Illustrated Parts List - IPL Update

365

Description of change

New articles Antivibration element 503 63 76-03 and 503 63 76-04(hard)

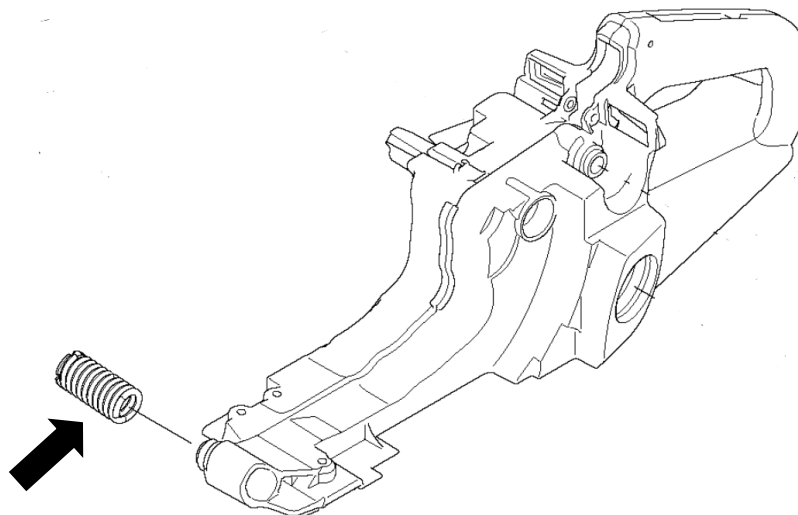
New Antivibration element with ground top on the metal spring. The plastic plug is changed. This gives longer thread length and therefor better fastening of spring in plastic plug.

Reason: Improved durability of antivibration element.
